Pin reference

Same data as the wiring diagrams above, as a flat table for quick lookup while soldering.

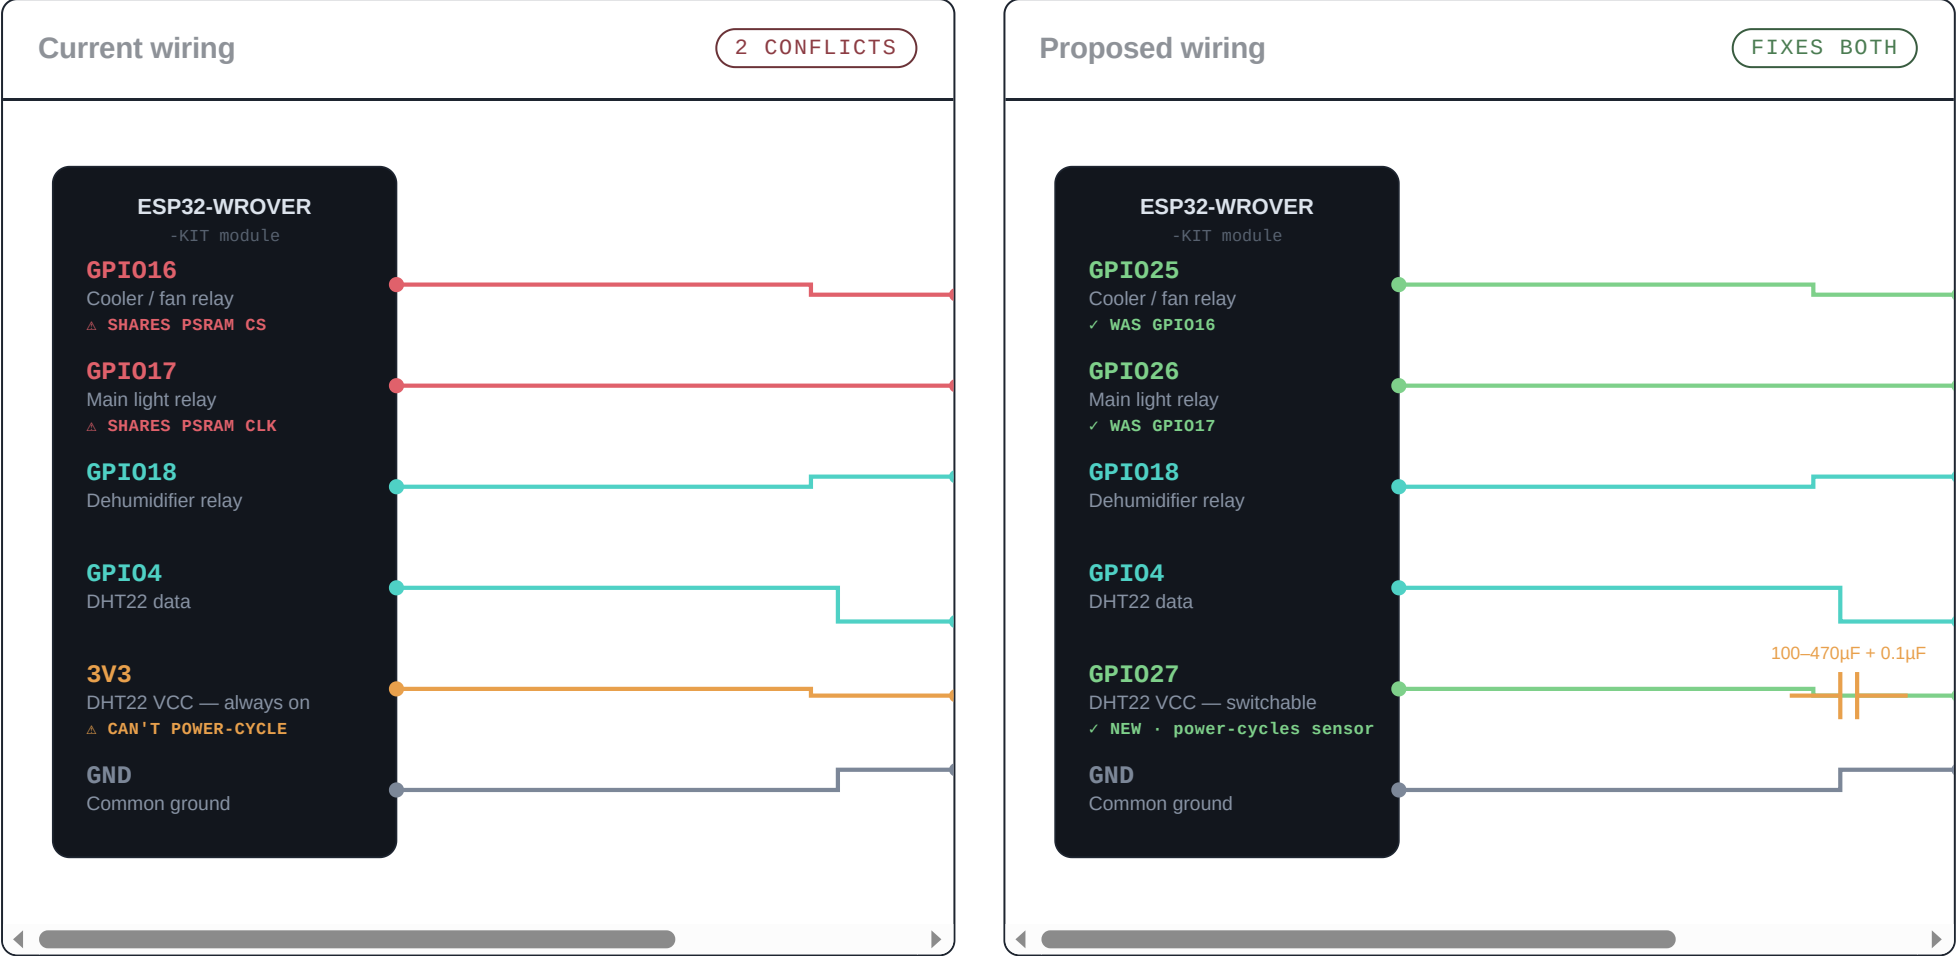
FUNCTION	CURRENT PIN		PROPOSED PIN	NOTE
Cooler / exhaust fan relay	GPIO16	→	GPIO25	Moved off the WROVER module's internal PSRAM CS line
Main light relay	GPIO17	→	GPIO26	Moved off the PSRAM CLK line
Dehumidifier relay	GPIO18	—	GPIO18	Unchanged, no conflict
DHT22 data	GPIO4	—	GPIO4	Unchanged
DHT22 VCC	3V3 rail	→	GPIO27 (new)	Lets firmware hard power-cycle the sensor after prolonged read failure
Common ground	GND	—	GND	Unchanged
Brownout suppression	— physical addition only, no pin —			100–470µF electrolytic + 0.1µF ceramic across DHT22 VCC/GND, right at the sensor

Verify GPIO25/26/27 against your specific WROVER-KIT board revision before wiring — the dev board also breaks some GPIOs out to a camera header and JTAG, and the exact mapping differs between hardware revisions (v3 vs v4.1). If any of these three are already spoken for, GPIO13, GPIO14, GPIO32, or GPIO33 are equally valid substitutes — none are used by this firmware today.
